SERVICE BULLETIN

APPLICABILITY: 2017-23MY Impreza
2018-23MY Crosstrek
2019-24MY Forester
2022-24MY WRX
2019-24MY Ascent

NUMBER: 11-205-25

SUBJECT: DTC P1449 EVAP System Clog Detected /
Repair Procedure

DRAIN FILTER / DESCRIPTION OF DESIGN CHANGE:

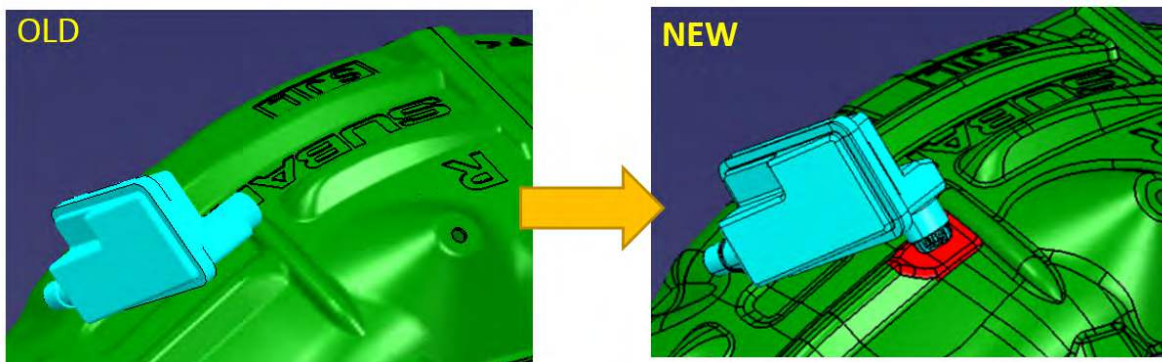
This bulletin announces the repair procedures to be followed when DTC P1449 (EVAP System Clog Detected) is detected by the Engine Control Module (ECM). New drain filter assemblies have been developed with an added protector to prevent debris build up. For some models, reprogramming and an additional mud guard will require replacement along with the drain filter. If DTC P1449 is found to be detected by the ECM, follow the service procedure outlined in this bulletin.

MUD GUARD / DESCRIPTION OF DESIGN CHANGE:

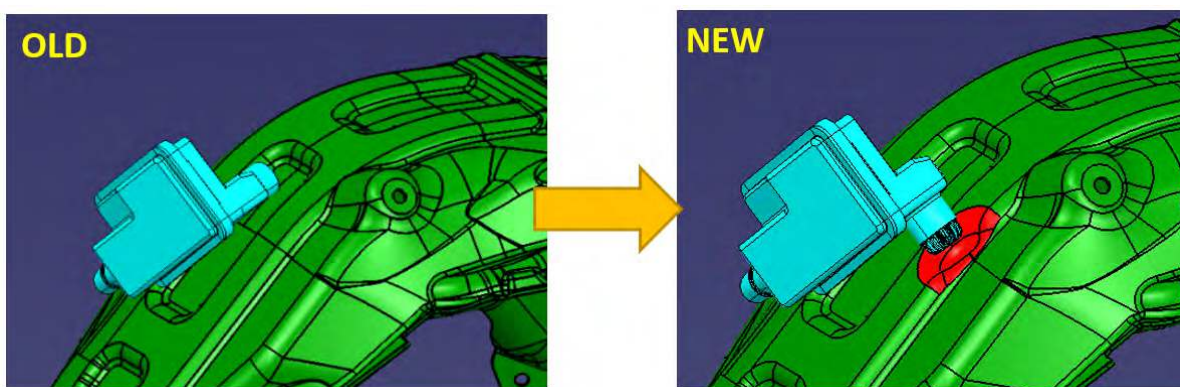
IMPORTANT: Mud guard replacement is **ONLY** required on Forester and WRX models.
